SHOREHAM NUCLEAR POWER STATION

SHOREHAM NUCLEAR POWER STATION - Unit 1
Docket No. 50-322

Enclosed herewith are 60 copies of additional information regarding SER Open Item No. 25, RCIC Temperature Sensors, which was previously identified as requiring clarifying information to complete NRC review.

Open Item No. 25

FIG. 1

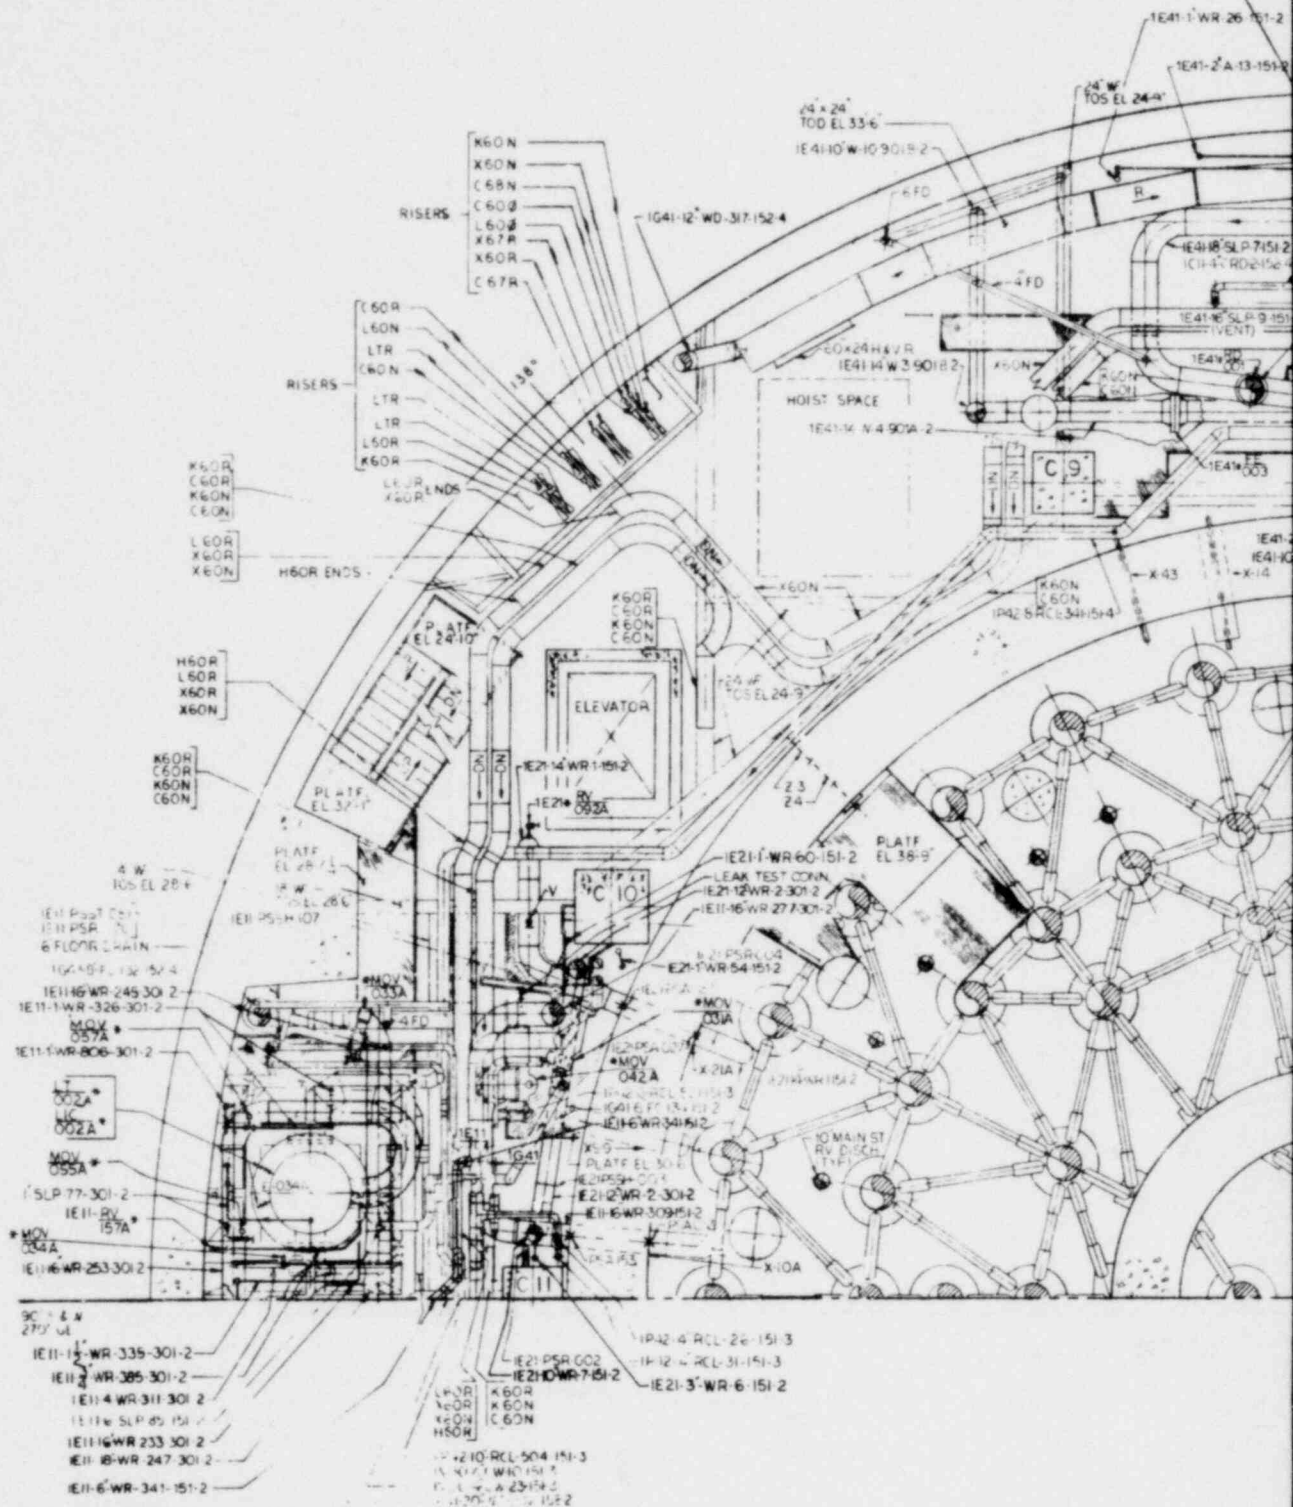
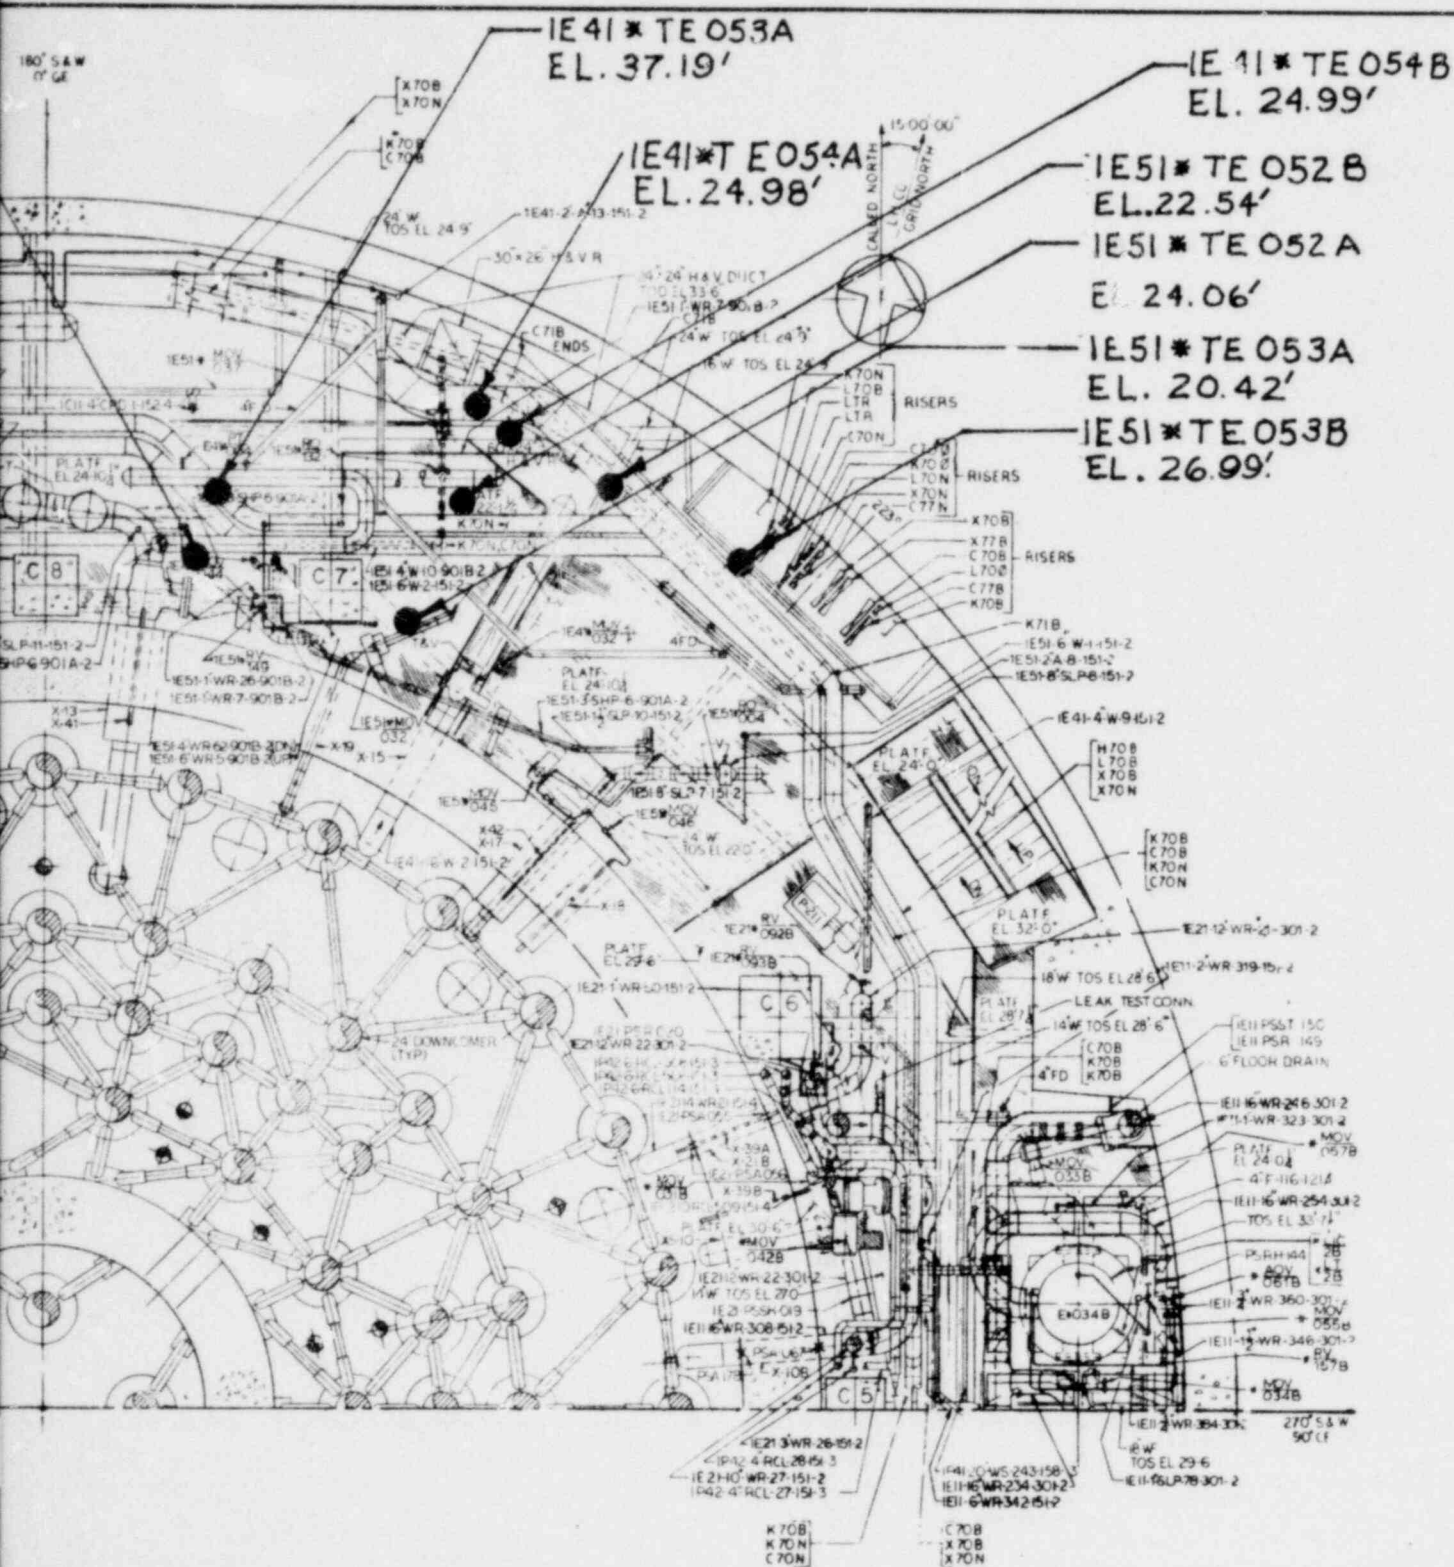
- a. Provide an illustration to show where the temperature sensor elements are located.
- b. Describe why a failure (steam line break) will not isolate both systems (HPCI and RCIC).

- a. See the attached table for the location of the temperature sensor elements.
- b. To the maximum extent possible, the temperature sensor elements are placed to minimize the possibility of interference between sensors and isolation of both the RCIC and HPCI systems. In order to be more conservative, for the condition of a break in the RCIC steam supply line it is assumed that HPCI also becomes unavailable and vice versa. This is discussed in detail in FSAR sections 3C.4.3.9 and 3C.4.4.9. As discussed therein, the plant can nevertheless be safely shut down. Note that each pipe break analysis considers, in addition to consequential effects, the worst single active failure associated with each pipe break.
